R	U.S. Department of the Interior BUREAU OF LAND MANAGEMENT		Sundry Print Reports 09/06/2022
	Well Name: BIG EDDY UNIT DI BB JABBA	Well Location: T20S / R32E / SEC 22 / SWSW / 32.5522 / -103.760677	County or Parish/State: LEA / NM
	Well Number: 103H	Type of Well: OIL WELL	Allottee or Tribe Name:
	Lease Number: NMLC065750A, NMNM33955	Unit or CA Name: BIG EDDY	Unit or CA Number: NMNM68294X
	US Well Number: 3002547227	Well Status: Approved Application for Permit to Drill	Operator: XTO PERMIAN OPERATING LLC

Sundry ID: 2682662

Procedure Description: **Surface Location Move, Casing/Cement, Drilling Variance Changes XTO Permian Operating, LLC requests permission to make the following changes to the original APD: No Additional Surface Disturbance Change SHL fr/270'FSL & 885'FWL to 290'FSL & 610'FWL. Well Stays in the Same Quarter-Quarter as Permitted Total SHL Move: 20'North & 275'East SHL change requested to optimize well pad layout, drilling efficiencies, and for safety purposes. Casing/Cement design per the attached drilling program. Attachments: C102 Drilling Program Directional Plan Multibowl Diagram

DRILLING PLAN: BLM COMPLIANCE (Supplement to BLM 3160-3)

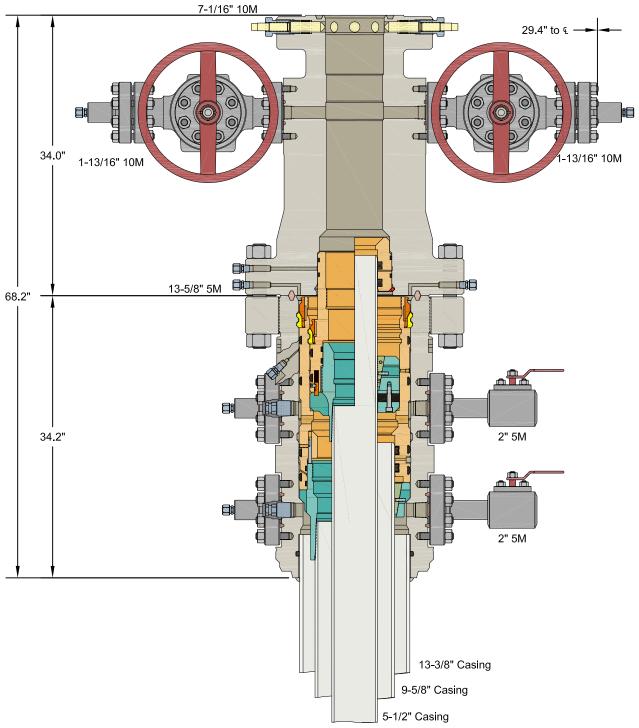
Permanent Wellhead – Multibowl System

A. Starting Head: 13-5/8" 10M top flange x 18-5/8" bottom

- B. Tubing Head: 13-5/8" 10M bottom flange x 7-1/16" 15M top flange
 - · Wellhead will be installed by manufacturer's representatives.
 - · Manufacturer will monitor welding process to ensure appropriate temperature of seal.
 - · Operator will test the 9-5/8" casing per BLM Onshore Order 2

- a. Wellhead shall be installed by manufacturer's representatives, submit documentation with subsequent sundry.
 - b. If the welding is performed by a third party, the manufacturer's representative shall monitor the temperature to verify that it does not exceed the maximum temperature of the seal.

Note: Picture below highlights BOP components that will be tested during batch operations

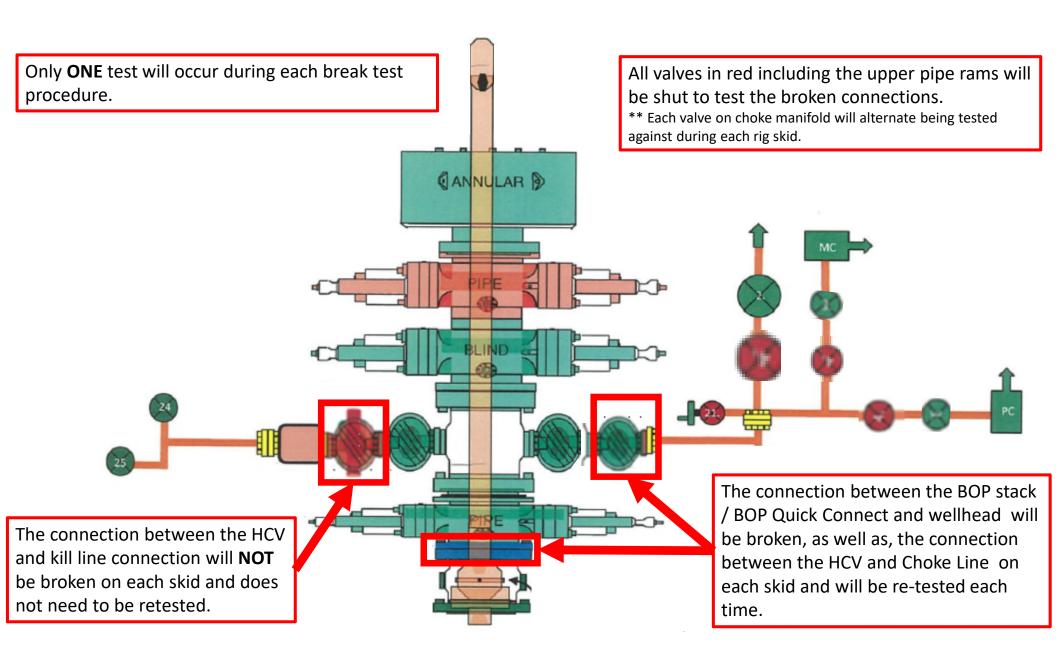
- 3. After performing a complete BOP test on the first well, the intermediate hole section will be drilled and cased, two breaks would be made on the BOP equipment.

- a. Between the HCV valve and choke line connection
 - b. Between the BOP quick connect and the wellhead
- 4. The BOP is then lifted and removed from the wellhead by a hydraulic system.

- 5. After skidding to the next well, the BOP is moved to the wellhead by the same hydraulic system and installed.
- 6. The connections mentioned in 3a and 3b will then be reconnected.

- 7. Install test plug into the wellhead using test joint or drill pipe.
- 8. A shell test is performed against the upper pipe rams testing the two breaks.

- 9. The shell test will consist of a 250 psi low test and a high test to the value submitted in the APD or Sundry (e.g. 5,000 psi or 10,000psi).
- 10. Function test will be performed on the following components: lower pipe rams, blind rams, and annular.

Based on discussions with the BLM on February 27th 2020 and the supporting documentation submitted to the BLM, we will request permission to ONLY retest broken pressure seals if the following conditions are met:

1. After a full BOP test is conducted on the first well on the pad.

2. The first intermediate hole section drilled on the pad will be the deepest. All of the remaining hole sections will be the same depth or shallower.

3. Full BOP test will be required if the intermediate hole section being drilled has a MASP over 5M.

4. Full BOP test will be required prior to drilling the production hole.
